Update Project Proposal: SFF-TA-1037 Connectors For Pluggable Multi-Purpose Module (PMM)

Presented: 2026-08-28

Update Project Proposal: SFF-TA-1037

Type Identification

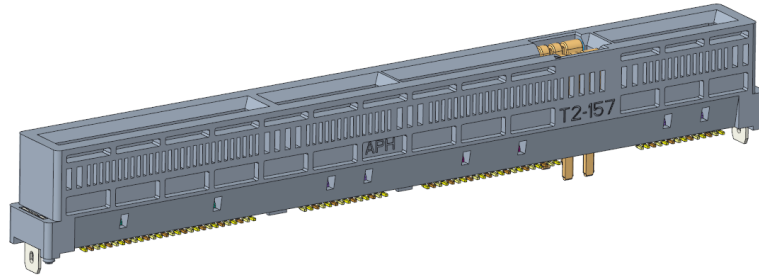
- Add 3 digits AIC thickness to the ground type code

High Speed Connectors

Tx-xxx

157: For 1.57mm AIC thickness

- 1: Ground not linked
- 2: Ground linked

Power Connector

T-xxx

157: For 1.57mm AIC thickness
